**DATE:** June 8, 2022

Certificate of Appropriateness Request: H-13-22  
Applicants: Tristan and Kristen Adamczuk  
Location of Subject Property: 97 Union St N  
PIN #: 5620-78-8882  
Staff Report Prepared by: Brad Lagano, Senior Planner

- Applicants’ requested modification: after-the-fact approval of architectural deviations to the approved detached garage elevations including removal of four (4) dormer features (Exhibits B, D).

**G03**

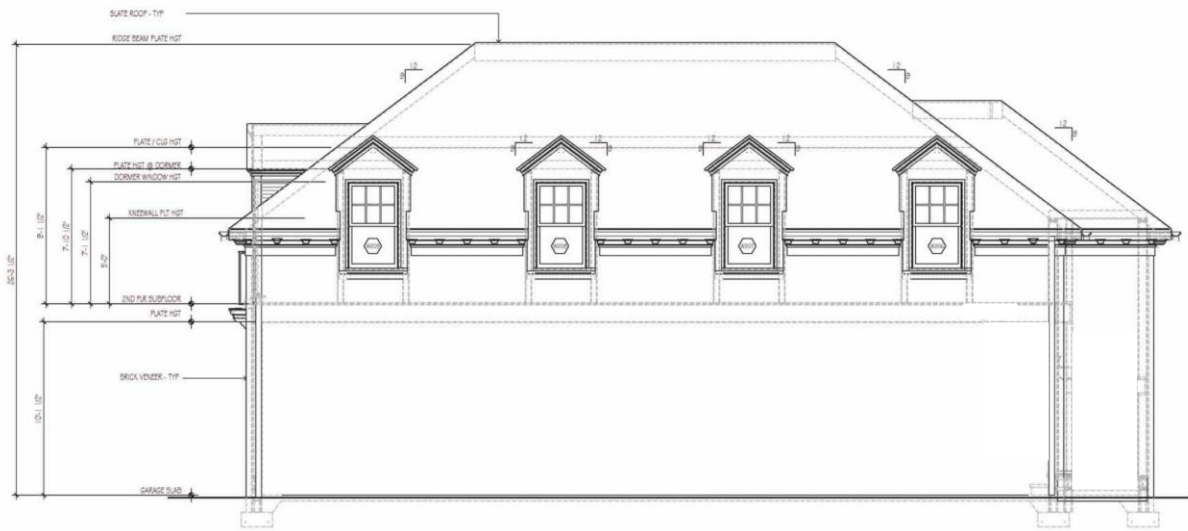
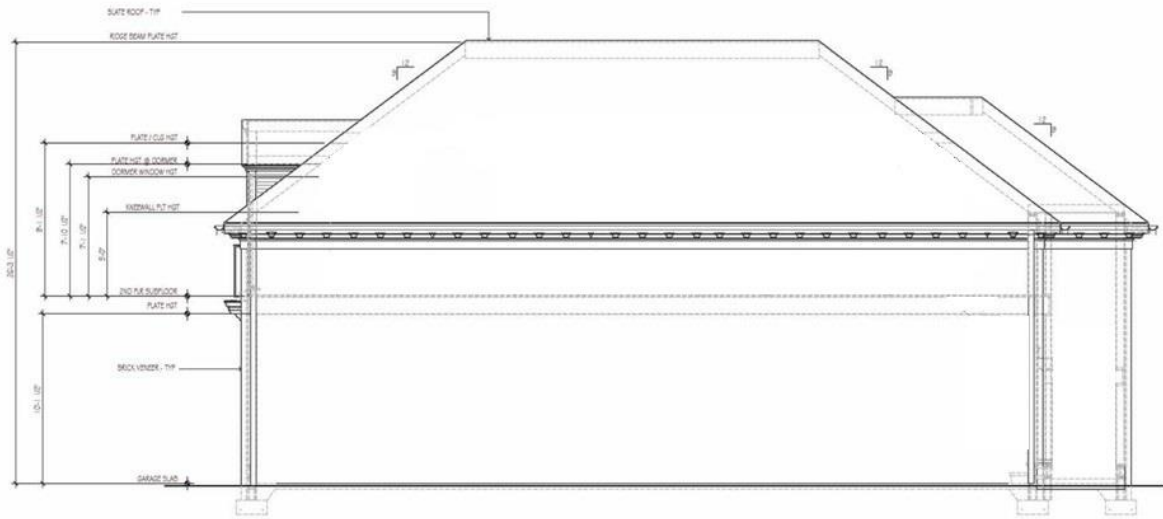
- The new garage was referenced in the recorded order as sheet GO3, Exhibit G, which showed the detached garage elevations to include four (4) dormer features on the rear side (Exhibits D, E).

- Completed construction of the new garage excluded four (4) dormers on the rear façade, contrary to the approved elevation. The building’s rear wall now includes a solid brick façade with no variations (Exhibits F, G).

- As can be seen on the approved elevations (Exhibit E), four (4) gable roof dormers were to be located on the second story, matching the four (4) dormers located on the opposite, garage door entrance, façade. Each dormer was designed with a single three-over-one window.
